EAST ROCKVILLE DESIGN GUIDELINES  
Rockville, Md.

March 12, 2019  
**Draft for Discussion**

**DRAFT FOR DISCUSSION v2**

**Building Height (Issue 7)**

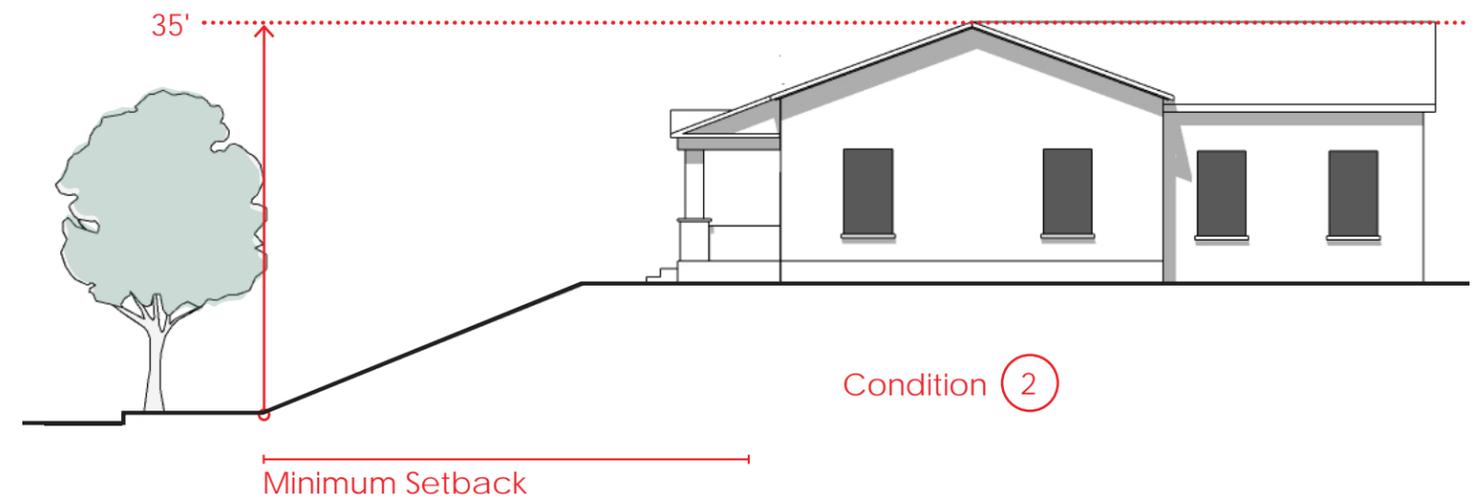
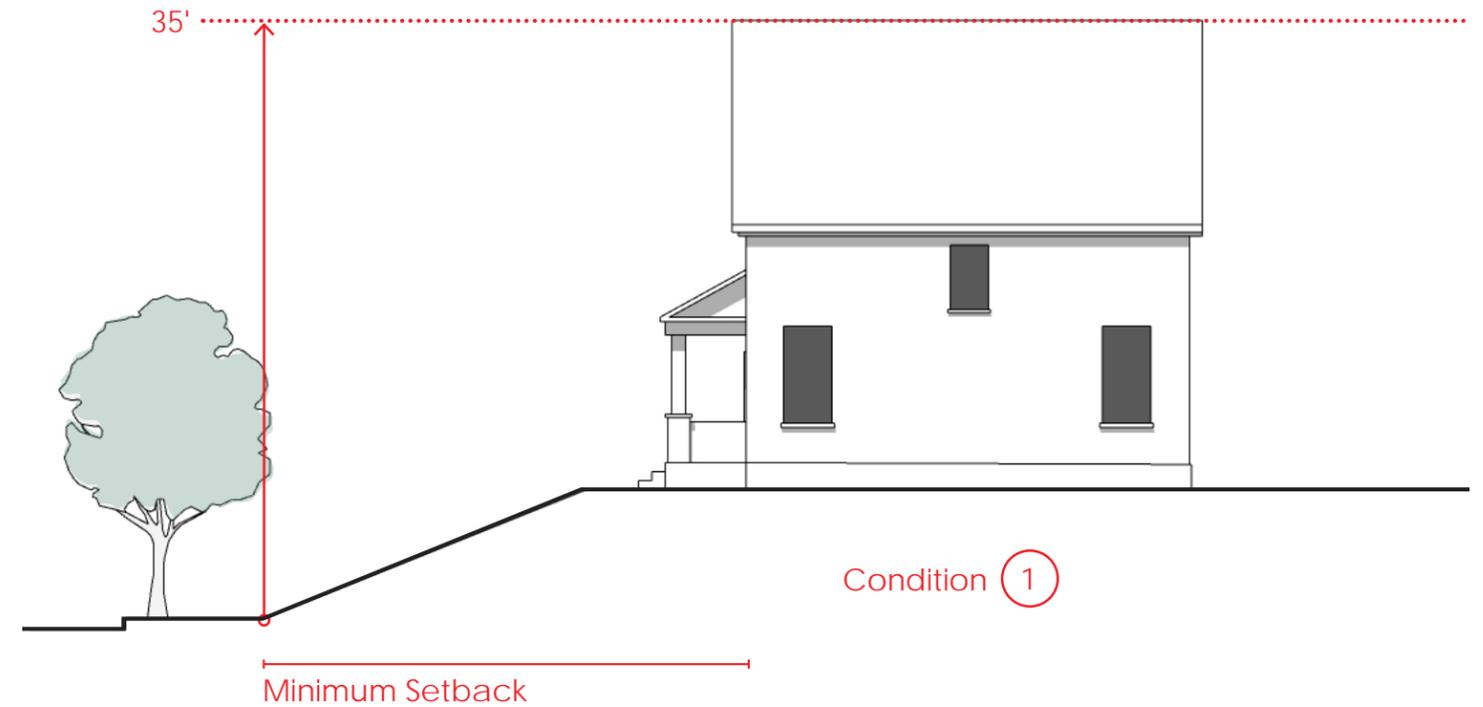
- In condition 2, I'd rather see them be allowed to go up to 2 levels rather than encroach on neighbor's set-backs. There's a house on my street that has a very steep front yard, and they have a 2 story house on top which I think is well done. Maybe measure the 35' from the average elevation of the front yard? When combined with the "first floor 2 feet above grade", this seems to be unfair to people with steep front yards (to limit them to one story this way).

- I mostly support this proposal if it is established as flexible guidelines, not rigid rules.
- 1) I suggest reducing the max height to 25 feet. I haven't literally measured any houses, but I've been estimating heights all weekend. My estimate is that 25 feet allows for foundation, two floors, and a pitched roof. 35 is really high given how flat most lots are. In addition to the exception specified on Page 48, properties on grades can be granted additional height equal to the average grade of the lot and its two adjacent neighbor lots.

- 1) Recommend measuring from primary level instead of grade.
- 2) last point: Why update existing code on this? - it could encourage multiple smaller roof pitches, but I am afraid it sooner will encourage very low, flat roofs.

- 2) How is "maximum lot coverage" defined?

**BUILDING ARTICULATION (ISSUE 8)**

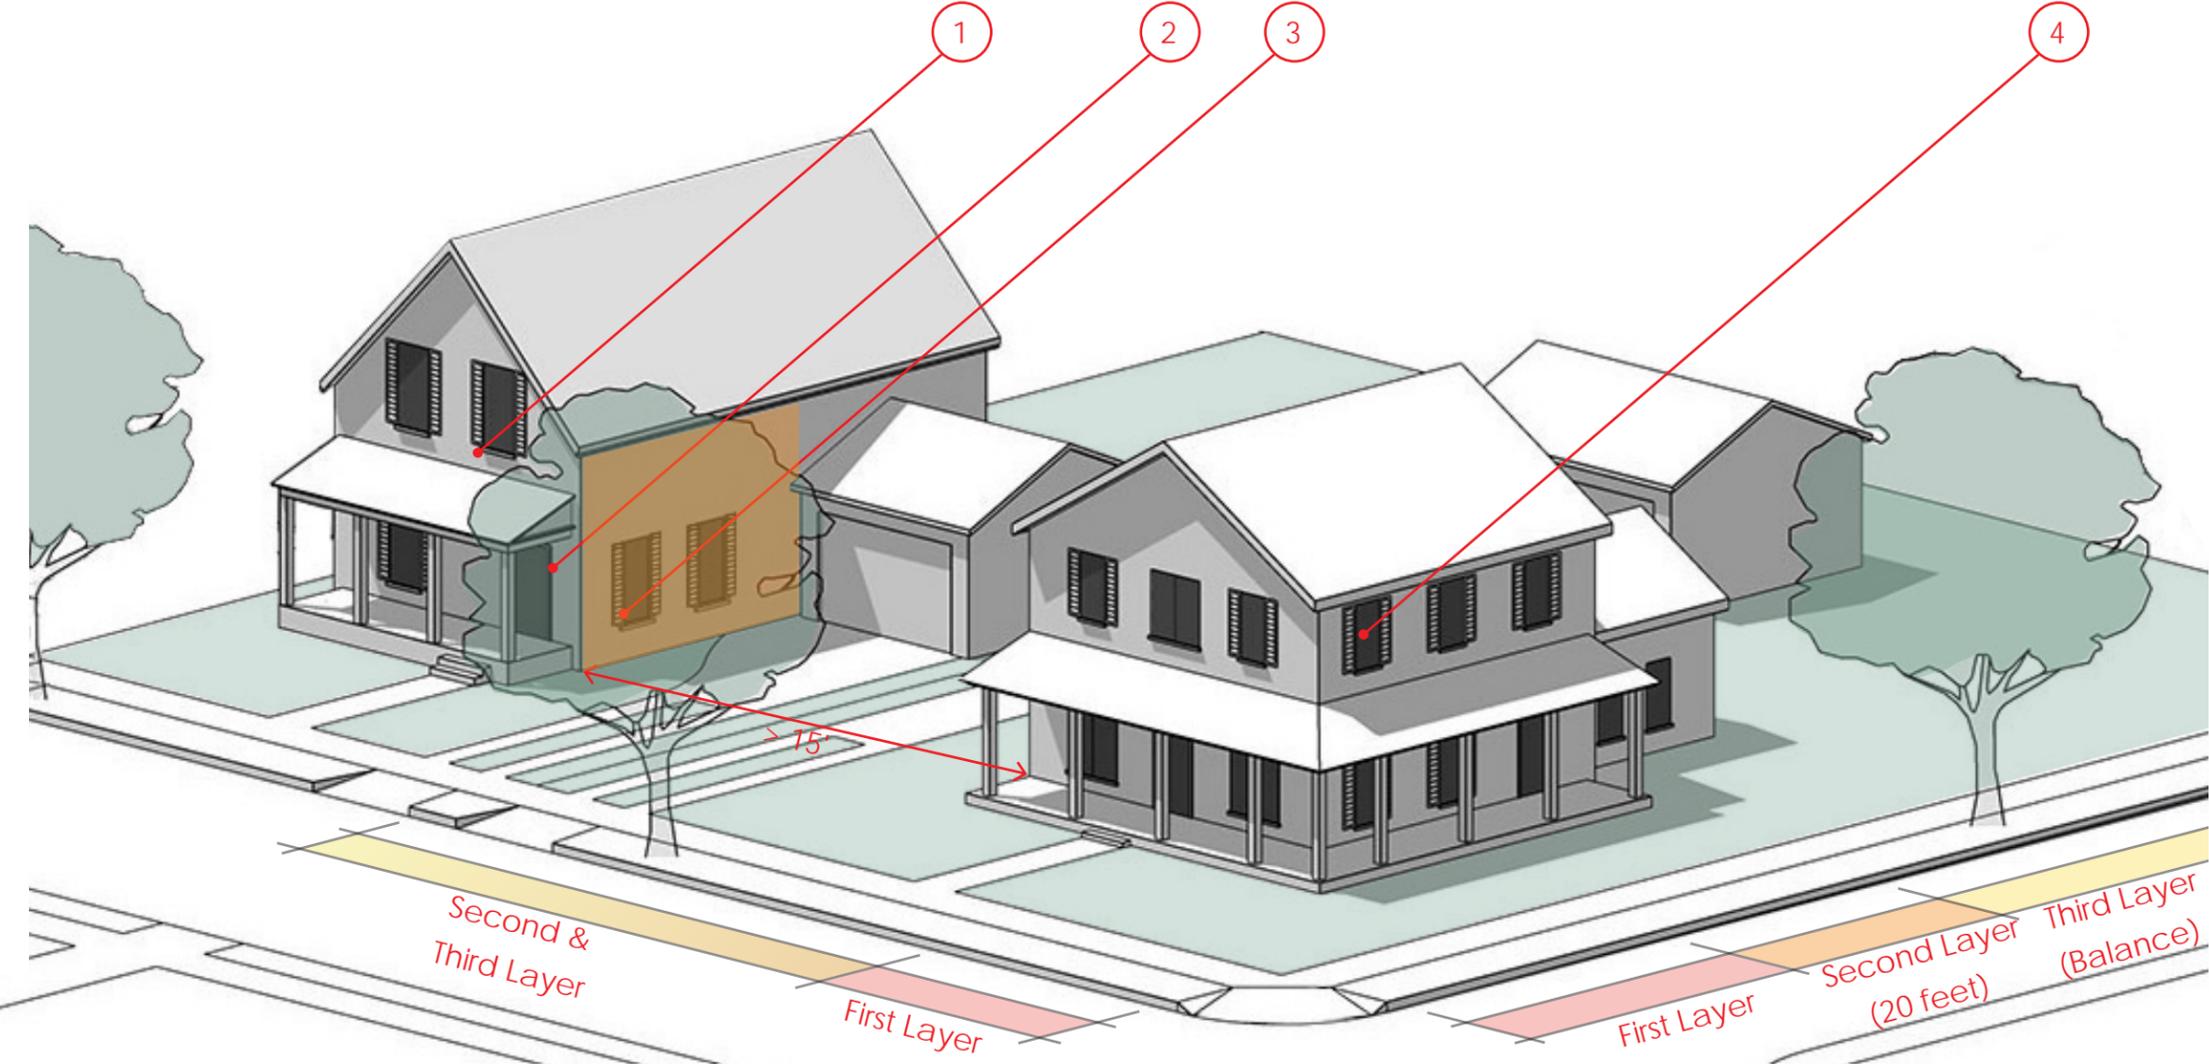
- 2) Maybe I'm misunderstanding this, but I plan to have some small trees and plants in my front yard that would (somewhat) block the view of parts of my house front. If that's the case, then I think this should be a "Should".
- 1) How do sunrooms get accounted for? Do they get added to the numerator or denominator for purposes of the percentage test, or are they omitted from both?
- 1) Change shall to should.
- 2) Front door coverage described in issue 1. Suggest removing duplication and clarifying clear placement here.
- 3) and 4) Change shall to should.
- 4) How will this be enforced if altered after initial construction? is this enforceable? otherwise perhaps make it a SHOULD?

**BUILDING MATERIALS (ISSUE 9)**

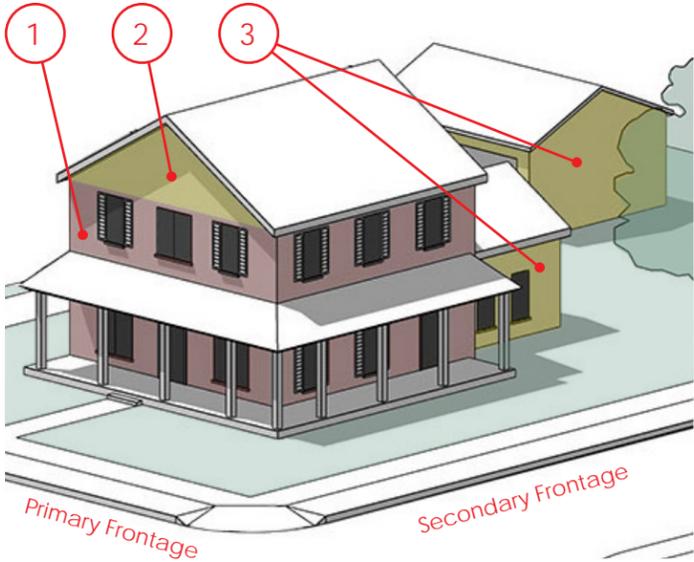
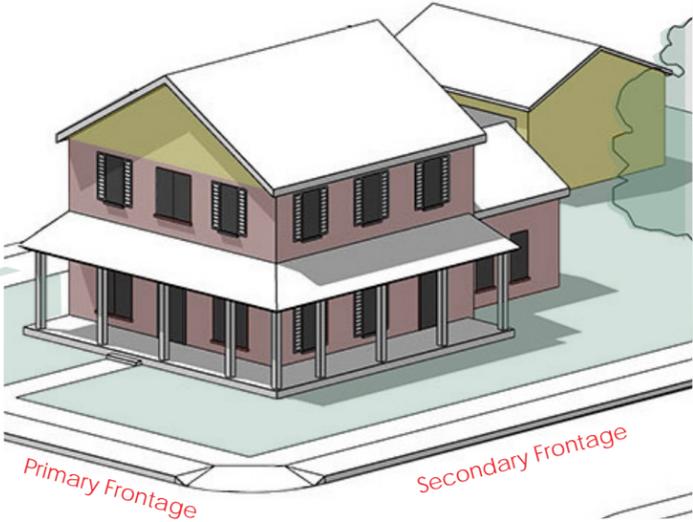
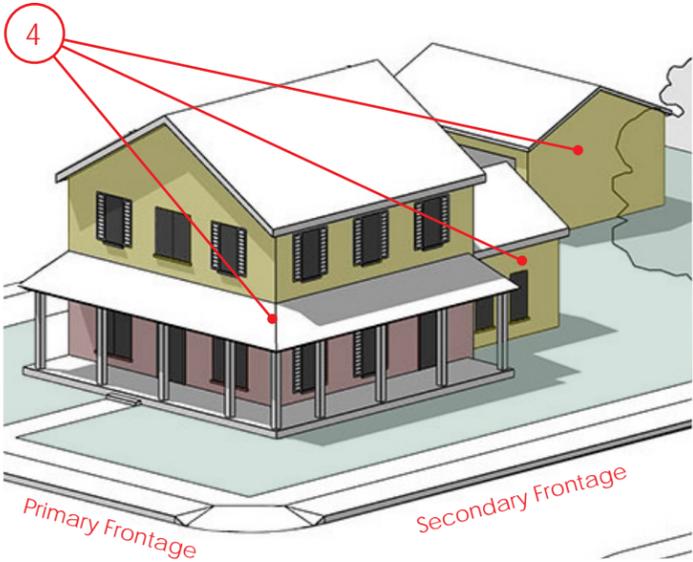
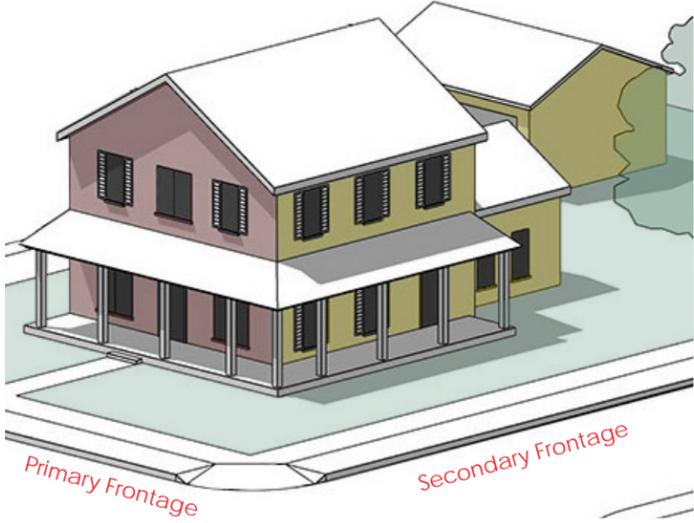
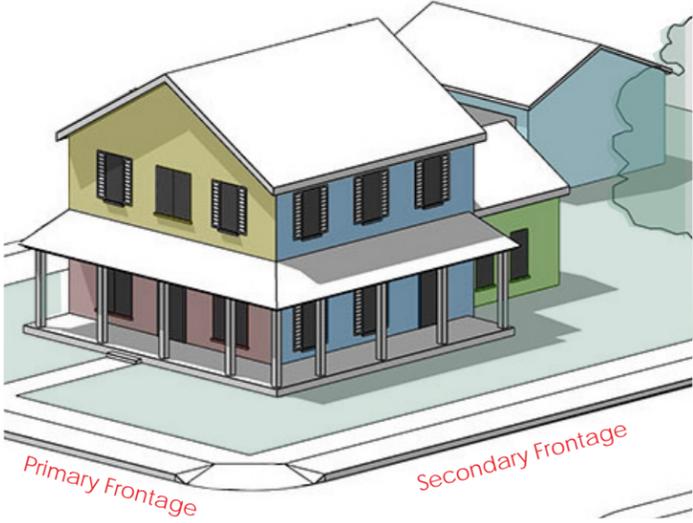
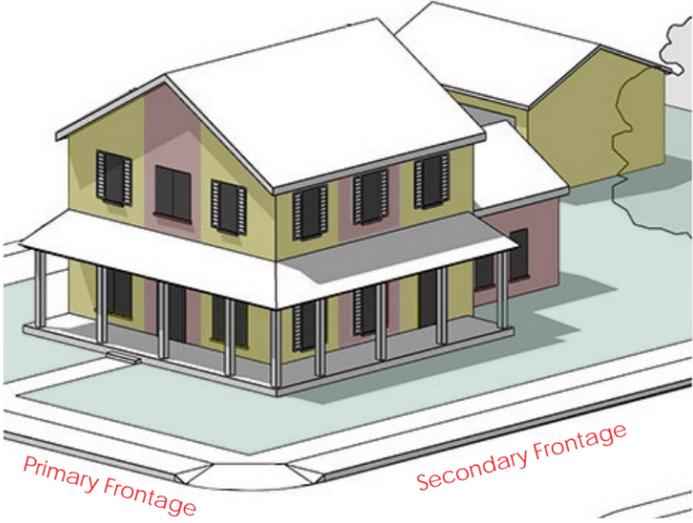
- I think these should all be "Shoulds". They sound like good guidelines, but I don't like to see them interfere with a) creativity, b) newer materials, or c) alt. materials. So long as it is safe, then I'm fine with materials being whatever

- 1) Vinyl siding should be permitted. It is found throughout the neighborhood in post-war houses. See photos of houses adjacent to comments on previous pages.

- Replace all "shalls" to should. Make stipulations that they have to be safe and within all building codes.
- Change rules from shall to should, as safety should be leading, not aesthetics having major cost and maintenance implications.

- 1) Alternatively: Houses may be built of any standard commercially available construction materials and need to meet all required safety guidelines. (we don't care.)

- 2) "Should" instead of "shall". Add "weight" after durability..... "durability and weight".

**PORCHES & STOOPS (ISSUE 10)**

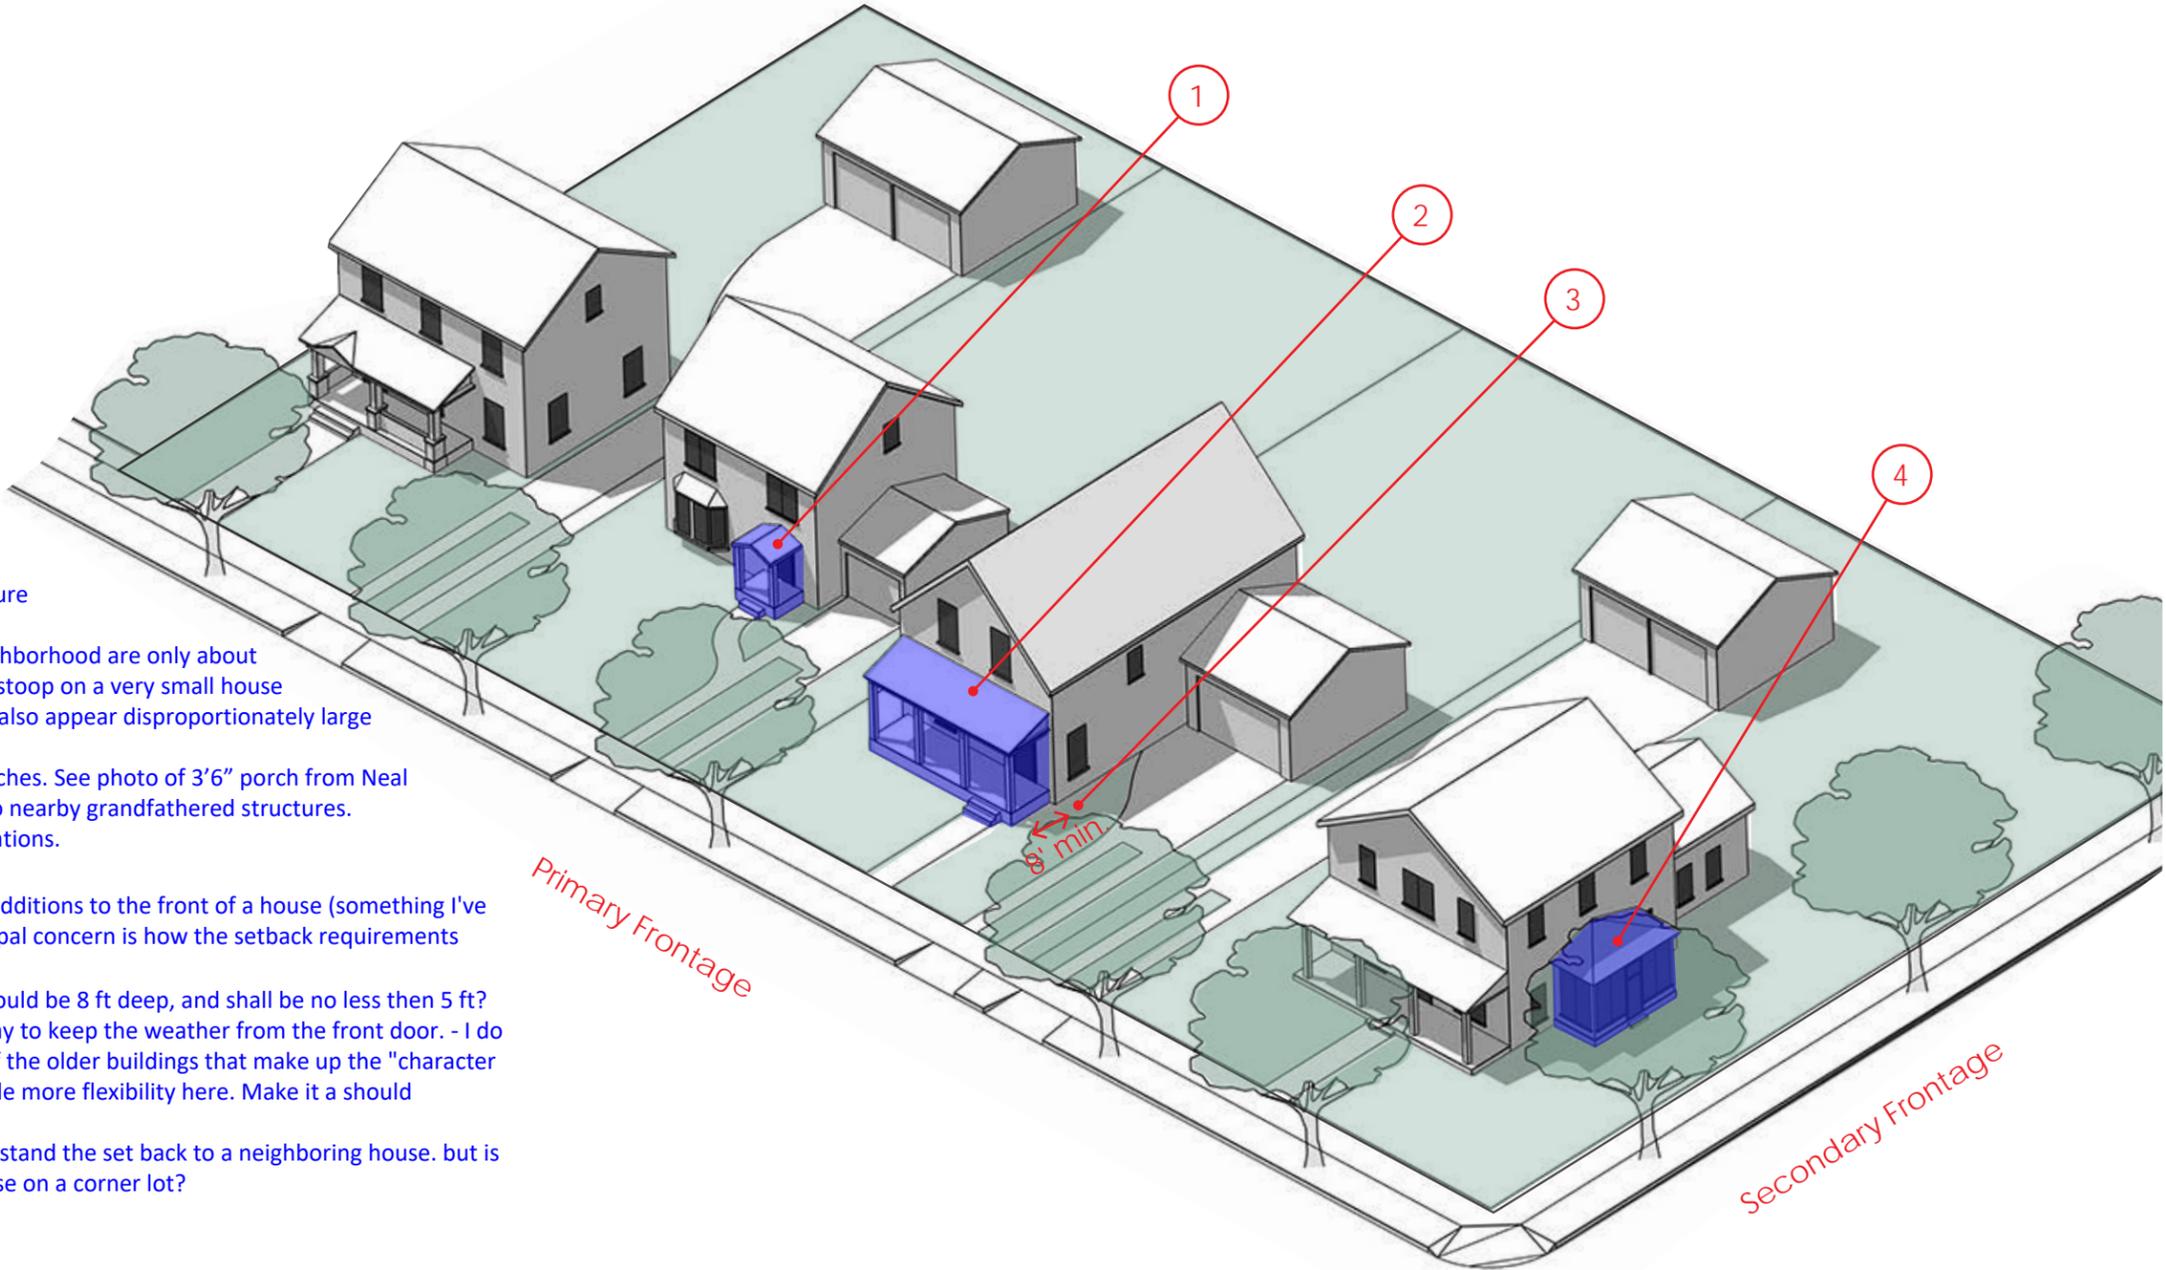
- First line: Need flexibility to account for different styles of architecture
- 3) Should be "Should". Sounds like good guidance, but too limiting.
- The original concrete stoops on most of the small houses in the neighborhood are only about five feet deep, and requiring a minimum eight foot depth for a new stoop on a very small house would not only result in increased impervious surface area, it might also appear disproportionately large in relation to the house.

- Many historic houses in the neighborhood have much narrower porches. See photo of 3'6" porch from Neal Drive. There should be flexibility on porch size if it is similar in size to nearby grandfathered structures.

- Define stoop and porch with respect to measurements or differentiations.
- 3) and 4) Change shall to should.
- As I mentioned during the meeting, these provisions don't address additions to the front of a house (something I've been considering and my house is at the top of a "slope"). My principal concern is how the setback requirements affect frontal additions

- 3) Porches, 8 feet deep - seems extremely deep. - could this be a Should be 8 ft deep, and shall be no less than 5 ft? Stoops of 8 feet, seems extremely deep, while only designed as a way to keep the weather from the front door. - I do not believe they should have the same requirements. Also - many of the older buildings that make up the "character of the neighborhood" do not have porches 8 ft deep. Perhaps provide more flexibility here. Make it a should

- 4) point 2: Should? - no strong preference either way.
- 4) point 3: How about a side set-back in case of a corner lot? I understand the set back to a neighboring house. but is there a way to provide flexibility to the secondary frontage of a house on a corner lot?

- 3) "Should" instead of "shall"
